Report of Staff Recommendation

File No.: 7-A-22-TOB

Request: BUILDING PERMIT

Address: 10101 Global Way

PHOTOMETRIC
 PLAN __ REVISIONS: △ 2022-06-17 REV 1 △ 2022-06-29 REV 2

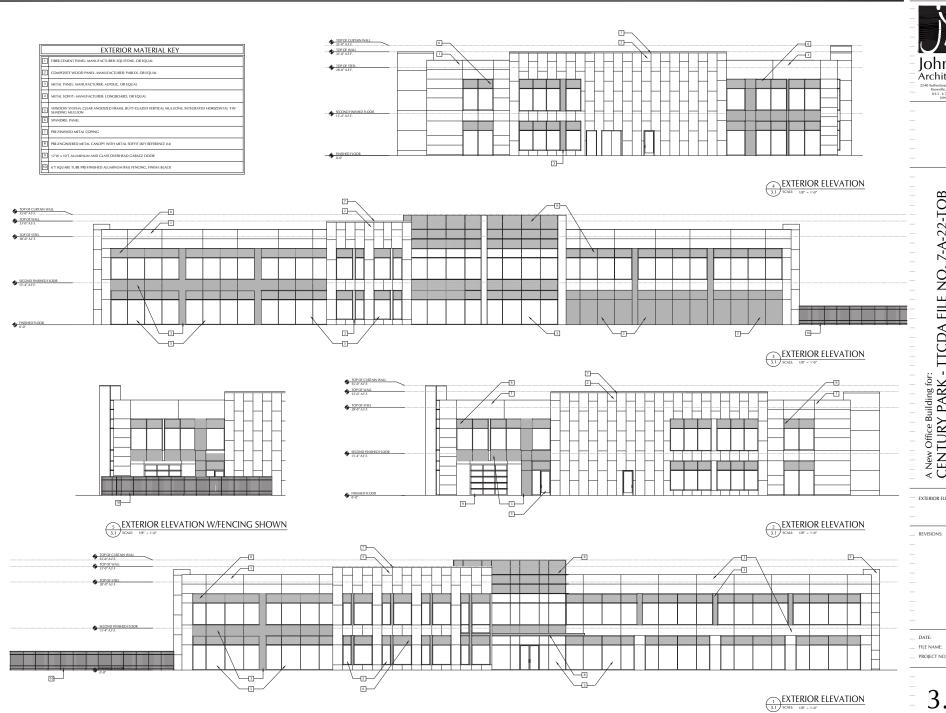
- 11) The proposed lighting includes seven light poles spread around the parking lot. The proposed light fixtures are full cut-off, utilize LED lighting, and meet the TTCDA Guidelines. Lighting levels likewise meet the TTCDA Guidelines.

DUMPSTER PLAN, ELEVATIONS AND DETAILS

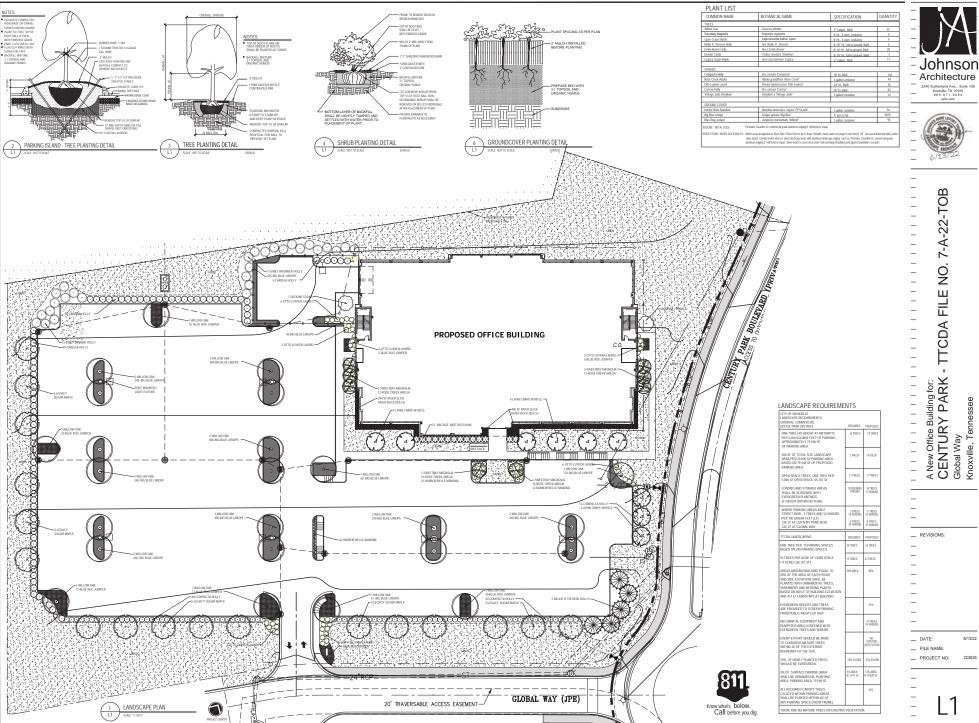
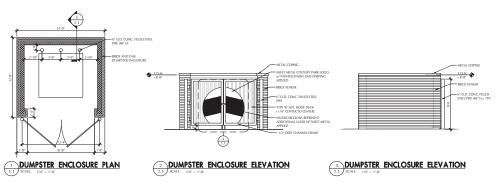
- 10) A dumpster will be provided on-site, and the dumpster enclosure will be clad in brick with a gate for access. The gate will be metal roof decking with an inset panel of sheet metal featuring the apartment complex logo.
